ADDENDUM #2 Questions and Clarifications

Service Lane Renovation (General Contractor) IFB #FED2019-13

Addendum Number: 02

Project Name: Service Lane Renovation

DOOR SCHEDULE, ELEVATIONS AND DETAILS

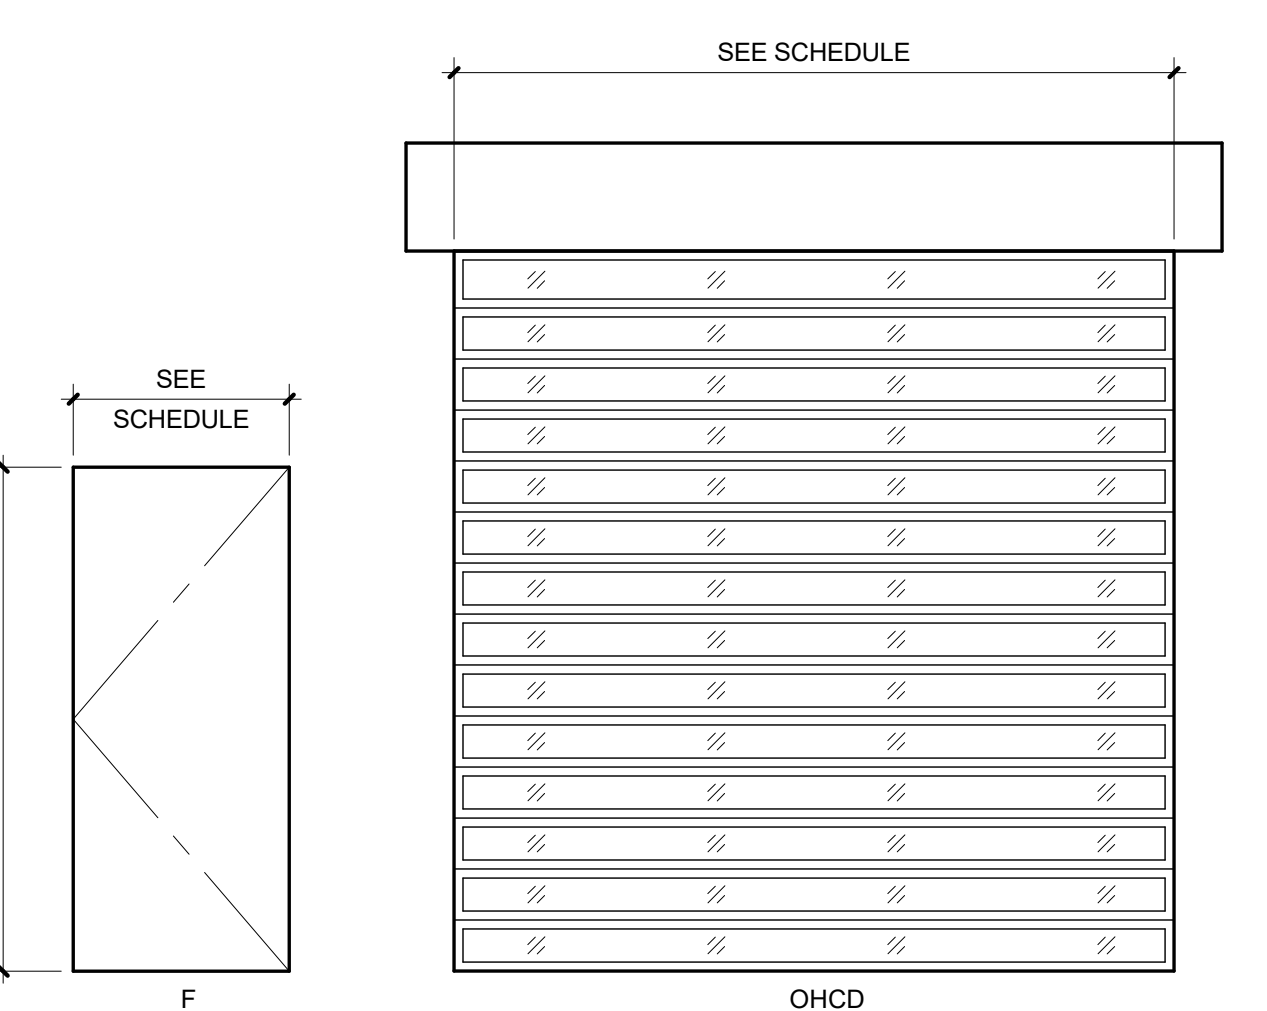
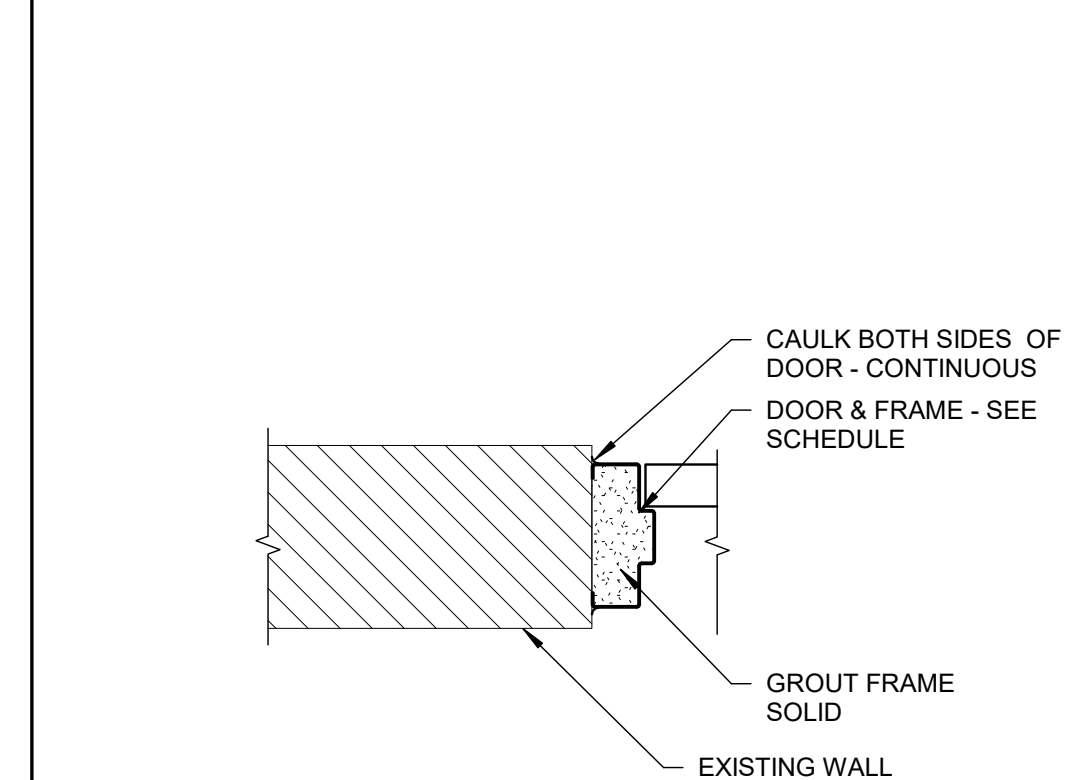
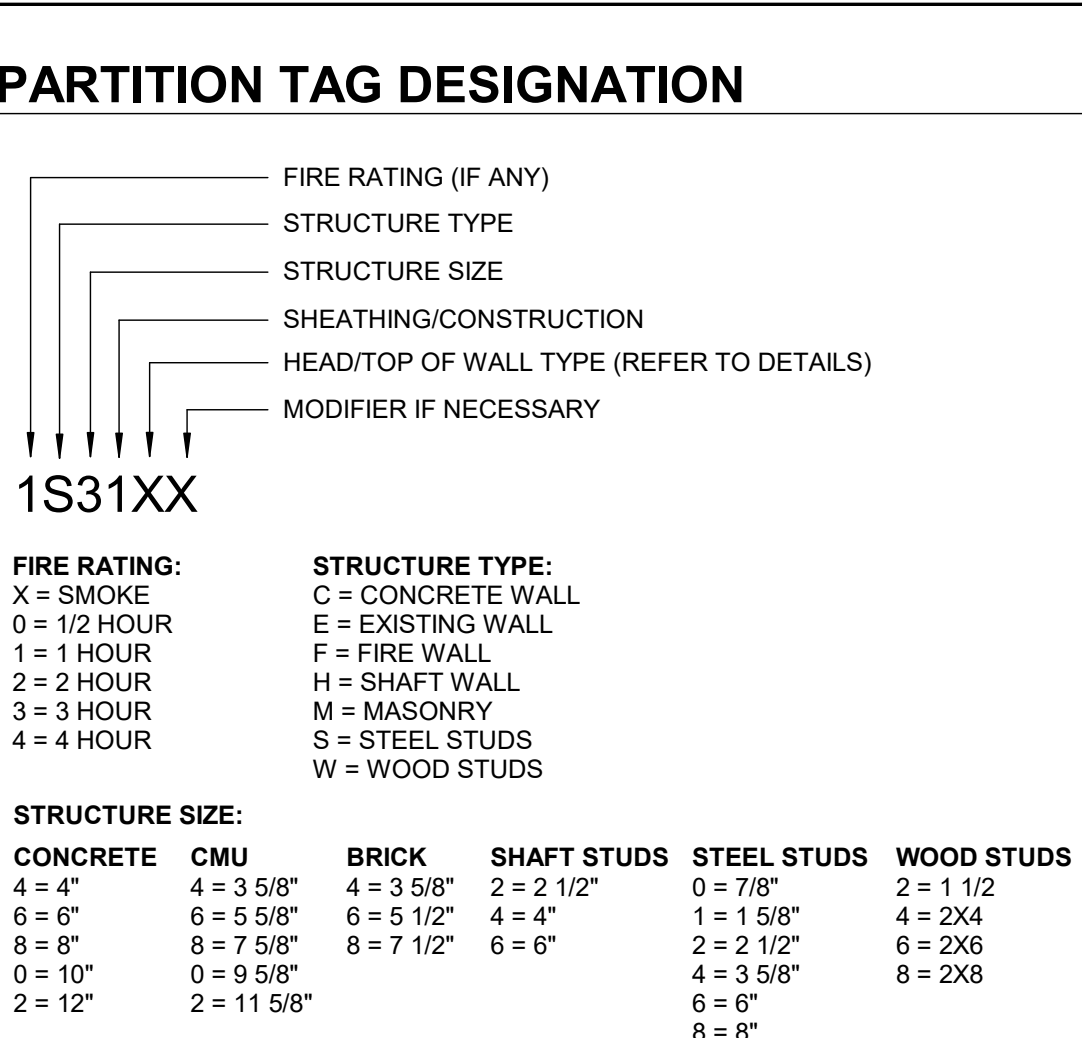
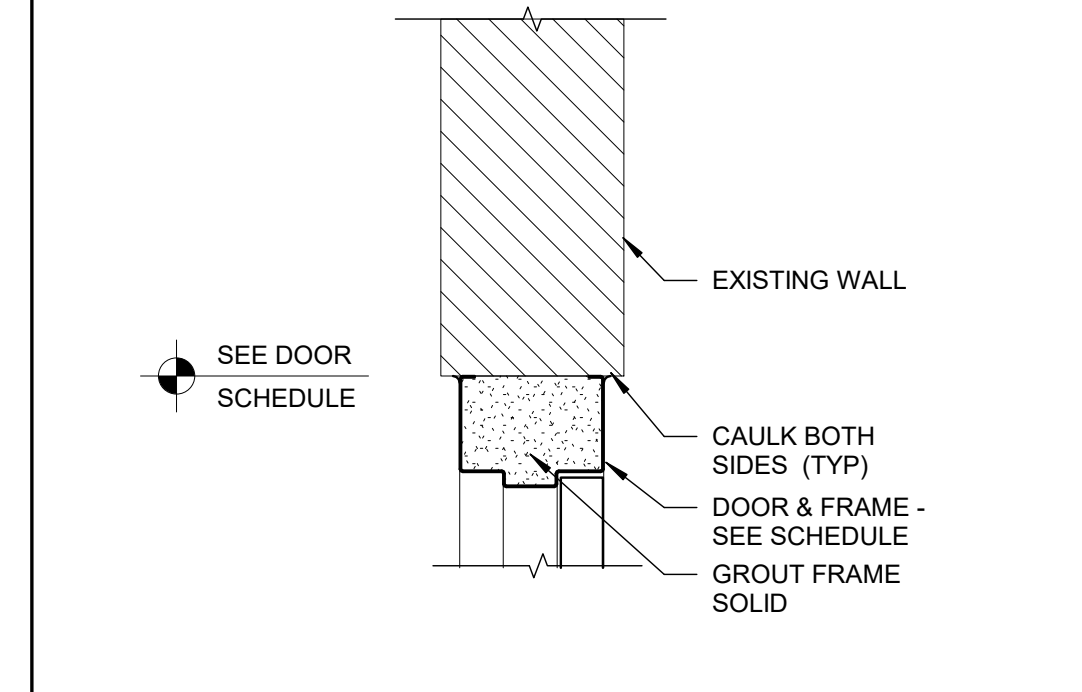
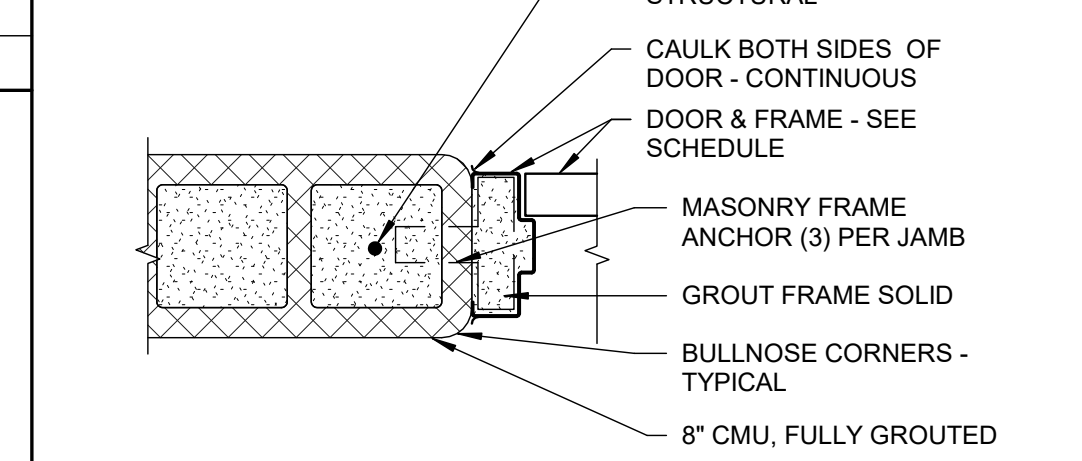
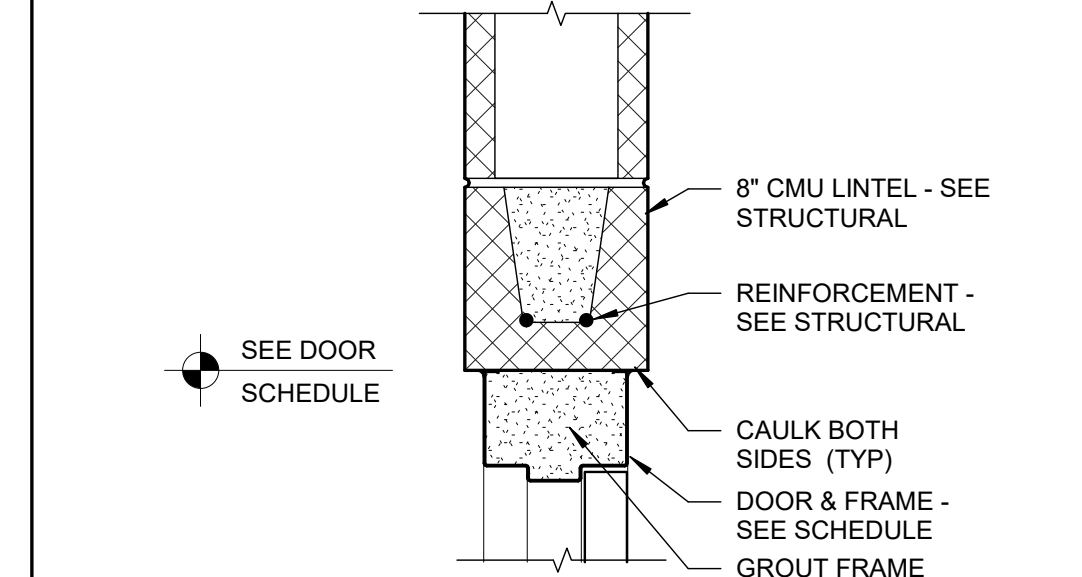
1. A7.1 Door Schedule, Elevations, and Details: Revised door hardware schedule.

GPMTD - 2019, PEORIA, IL
XJ404 FRESH WATER VEHICLE WASH SYSTEM
PLAN VIEW

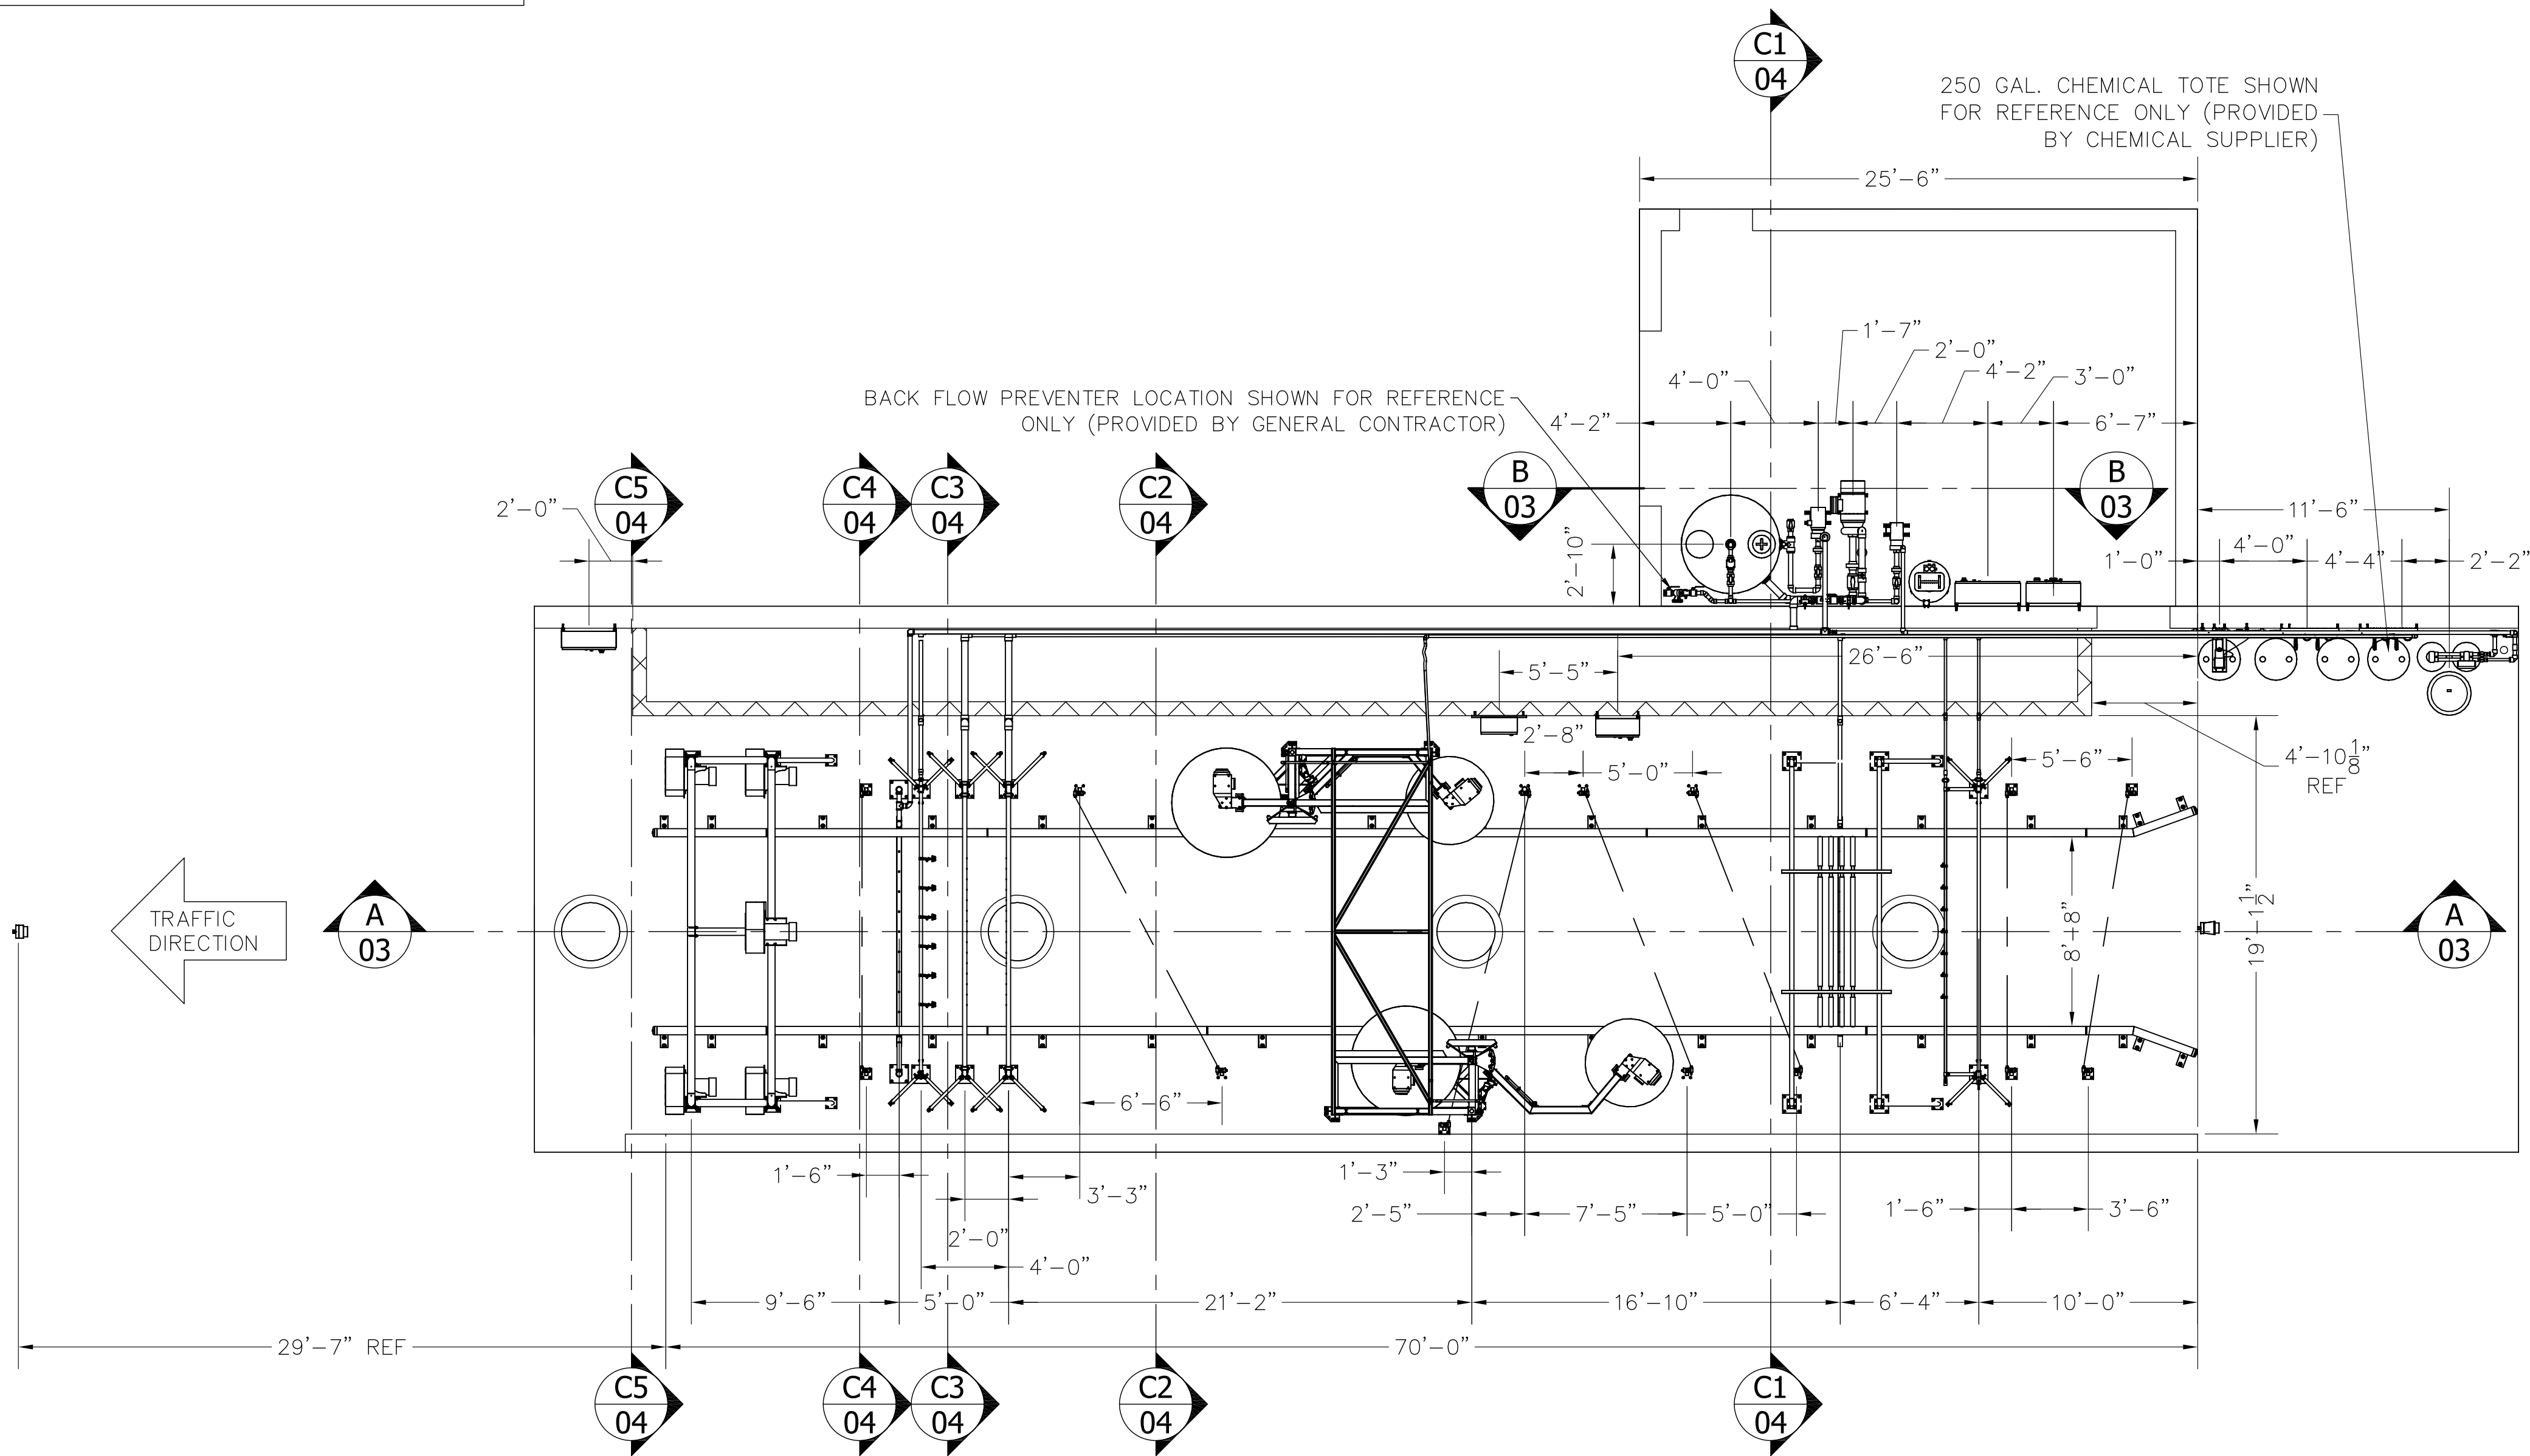
B	10/10/19	MOVED SPRAY BAR & TRENCH POSITION	TB	SIL	
A	9/26/19	EQUIPMENT RELOCATED	TB	SIL	
R	DATE	DESCRIPTION	BY	APPR

GPMTD - 2019, PEORIA, IL
XJ404 FRESH WATER VEHICLE WASH SYSTEM
SIDE VIEW

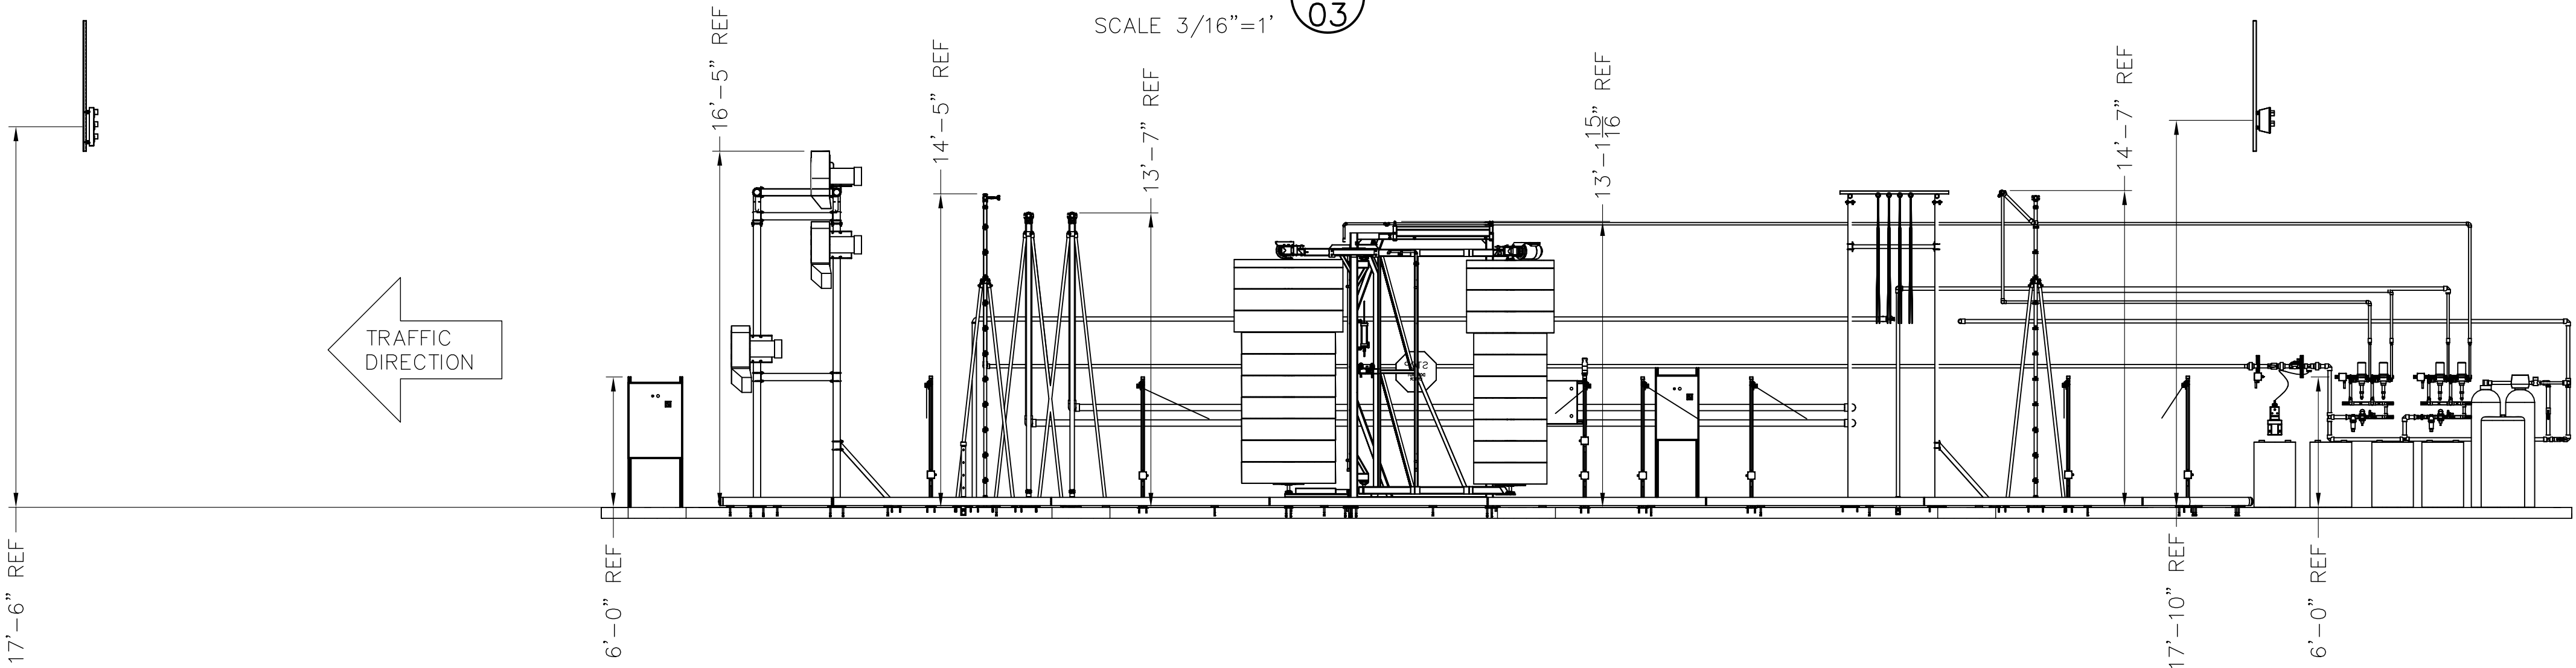
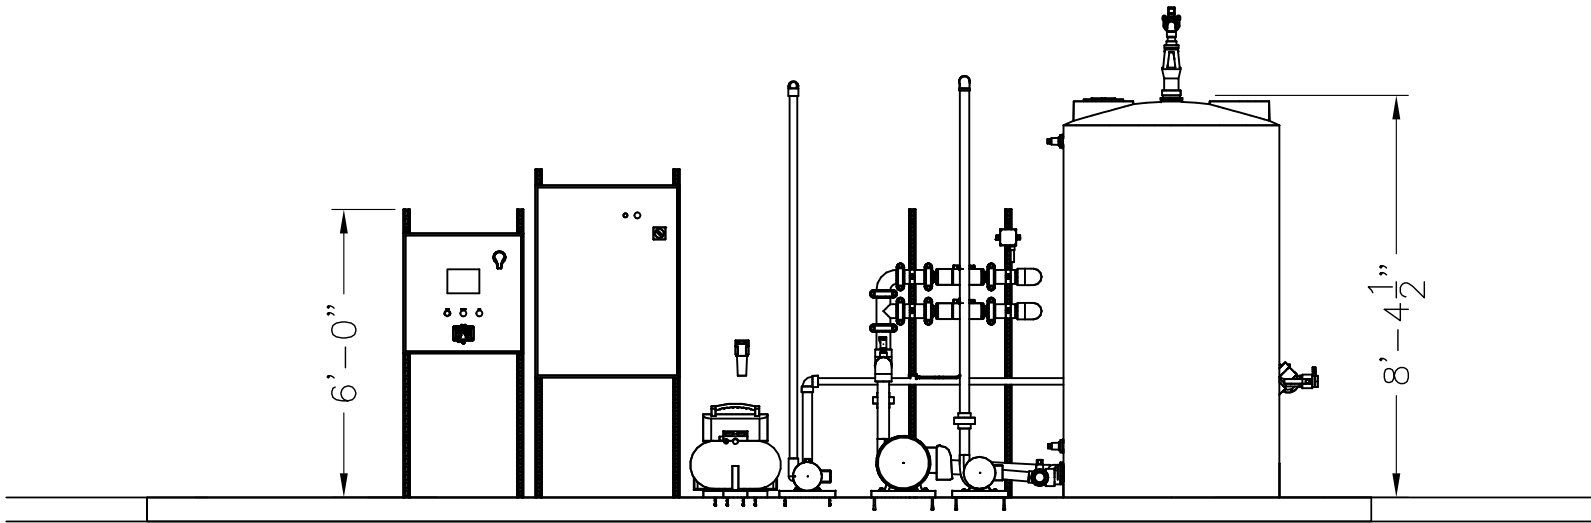
B	10/10/19	MOVED SPRAY BAR & TRENCH POSITION	TB	SIL
A	9/26/19	EQUIPMENT RELOCATED	TB	SIL
R.	DATE	DESCRIPTION	BY	APPR
